TOWN OF CARMEL PLANNING BOARD

# PLANNING BOARD AGENDA SEPTEMBER 16, 2020 – 7:00 P.M.

Re: Site Plan Lantern Pub Reconstruction 728 Route 6, LLC 728 Route 6, Mahopac TM # 76.22-1-54

The below is a response to comments from the Town Consultants and Staff as follows:

SITE PLAN

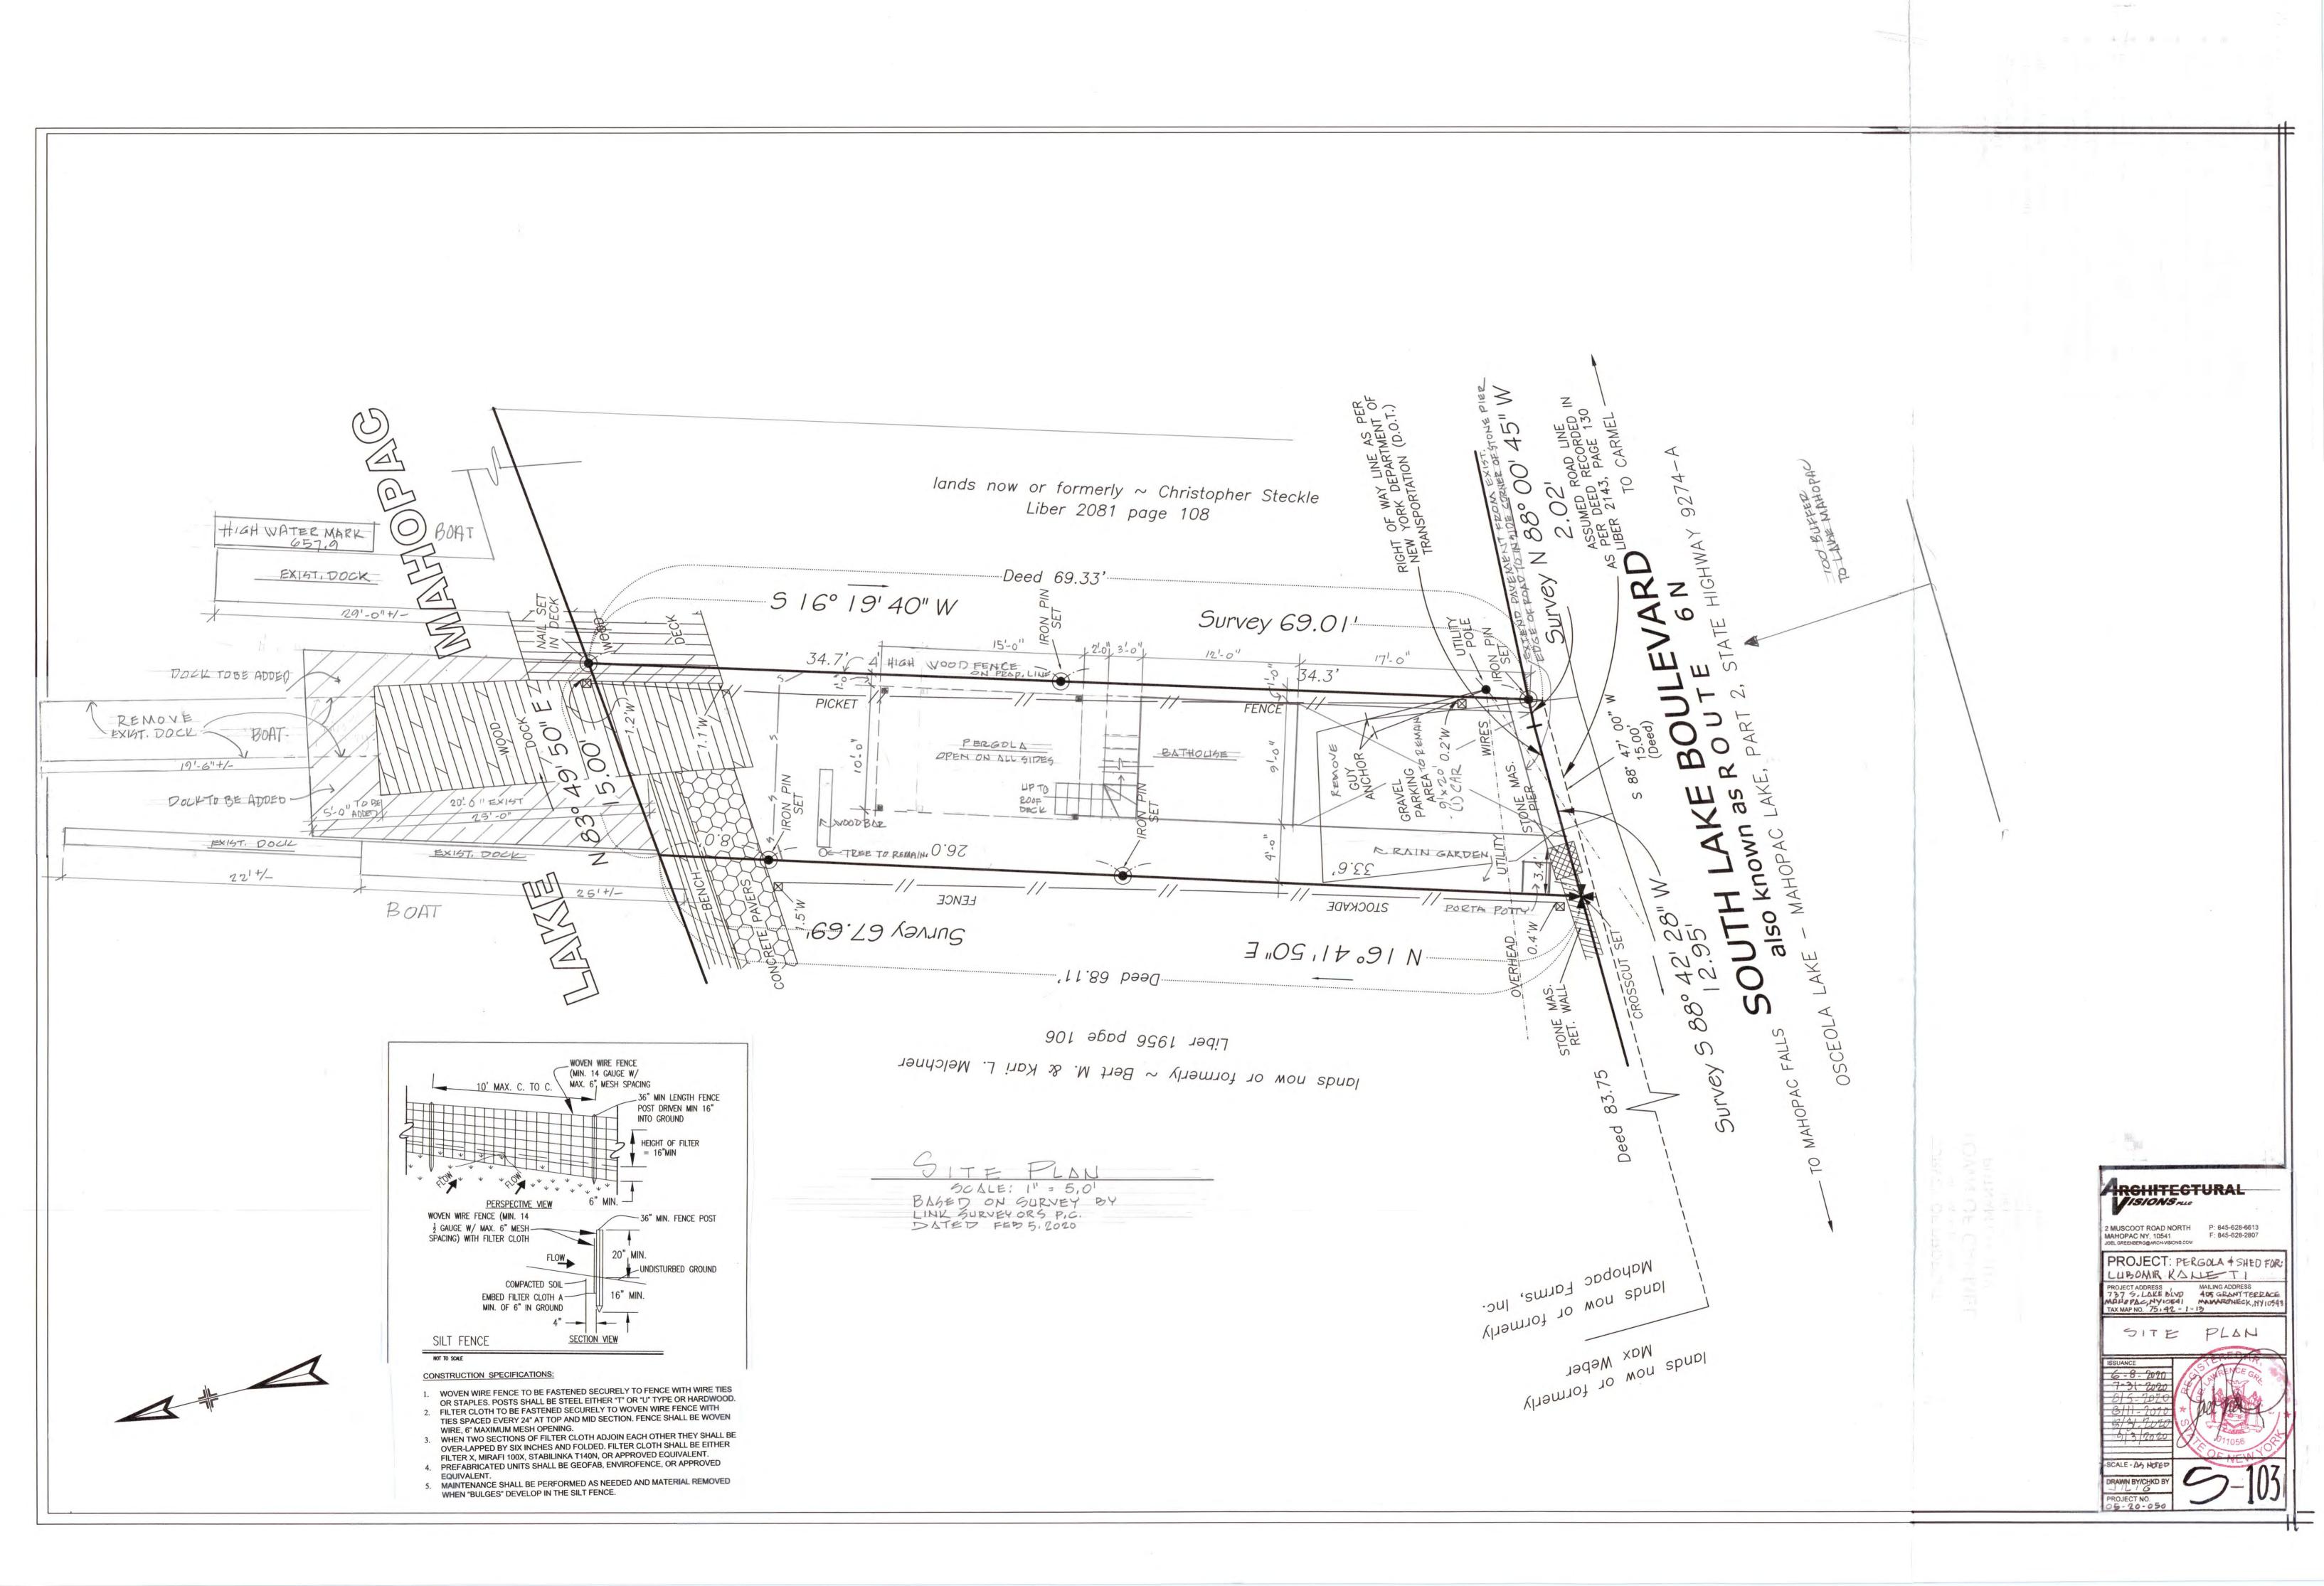
The Following is in response to the Town Engineers report dated August 12, 2020.

The Following is in response to the Town Planner's memo dated August 19,2020.

The following is in response to The Director of Code Enforcement's memo dated August 19, 2020

- 1. A Town of Carmel Flood Plain Permit will be submitted.
- 2. The 100 FT buffer from Lake Mahopac has been added to the Site Plan.

- 1. All the items indicated in section 156-27 are noted on the Site Plan.
- 2. We are responding to NYS DOT comment letter.
- 3. The Site Plan has been changed to reduce the area of the bathhouse and pergola. The appropriate variances are shown on the zoning chart.
- 4. The only utility that is proposed is electric.
- 5. Lighting is proposed for the bathhouse.

- 1. We have submitted the revised drawings to NYS DOT.
- 2. The Site Plan has been revised to reduce the size of the Bathhouse.
- 3. The parking calculations have been revised.
- 4. Lot width has been added to the zoning chart.
